1990 Corvette: Service Bulletin: Clutch Apply Plate Material Changed to Powdered Metal

Subject: CLUTCH APPLY PLATE MATERIAL CHANGED TO POWDERED METAL

Model and Year: 1990 ALL CARS, TRUCKS, VANS WITH 4L60 (700-R4) AUTOMATIC TRANSMISSION

Bulletin Number: 90-189-7A - (03/06/1990)

The following dates show when changes went into effect: (Figure 1)

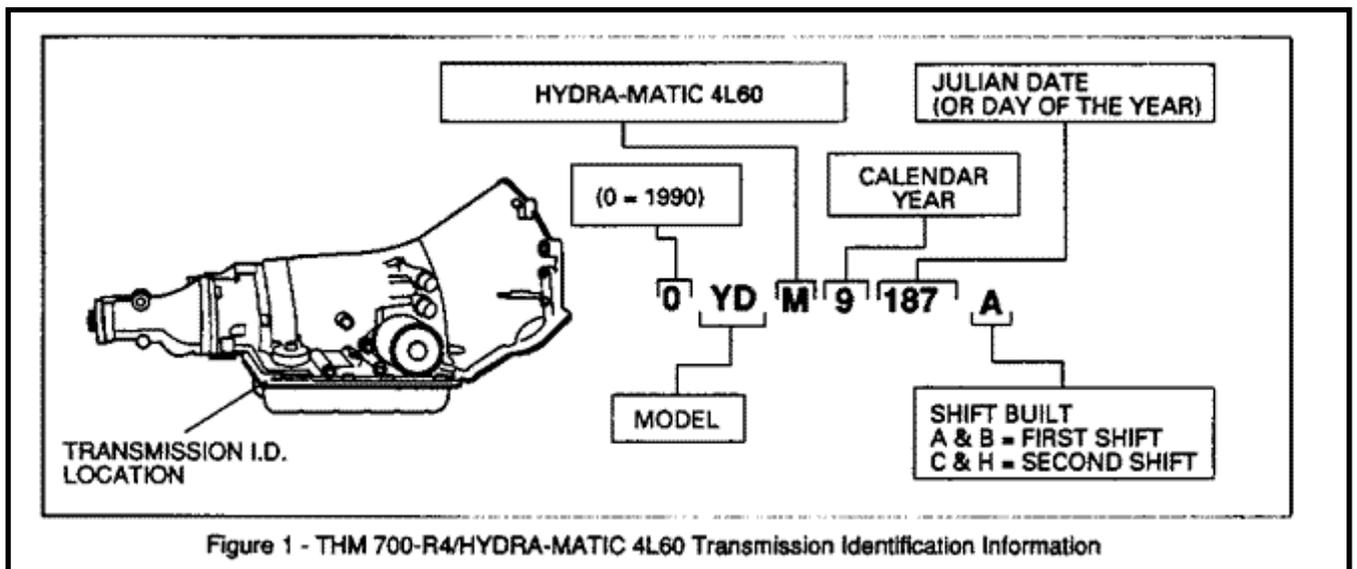
This bulletin covers a material change for the forward and 3-4 clutch apply plates. These clutches will now contain apply plates manufactured from powdered metal instead of steel.

Apply Plate Start of Production Date

Forward January 25, 1990 (Julian Date 025)

3-4 January 29, 1990 (Julian Date 029)

The new powdered metal plates are interchangeable with the current steel plates. Dimensions of the new powdered metal plates are the same as the steel plates. Powdered metal plates will appear darker in color than previously produced steel plates.

Part numbers have changed. (Figure 2)

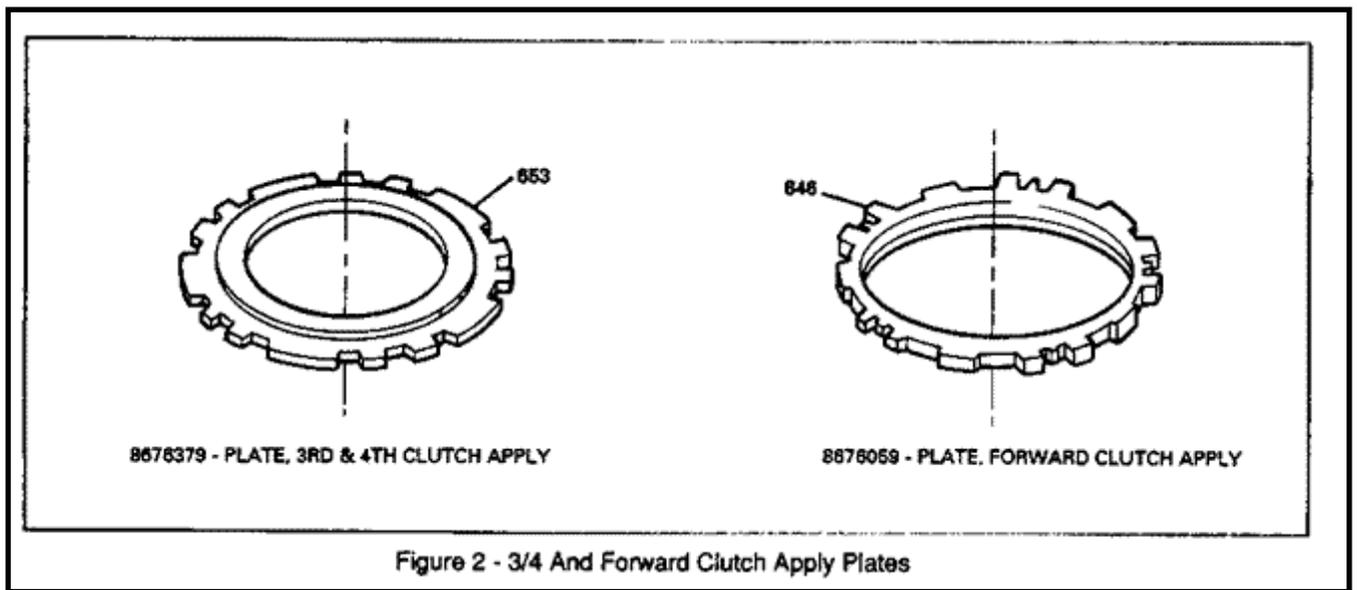
Part Number Description

8663785 Apply Plate - Forward Clutch (steel)

8667423 Apply Plate - 3-4 Clutch (steel)

8676059 Apply Plate - Forward Clutch (powdered metal)

8676379 Apply Plate - 3-4 Clutch (powdered metal)

When GMSPO stock of steel plates is used up, powdered metal plates will be available for service.
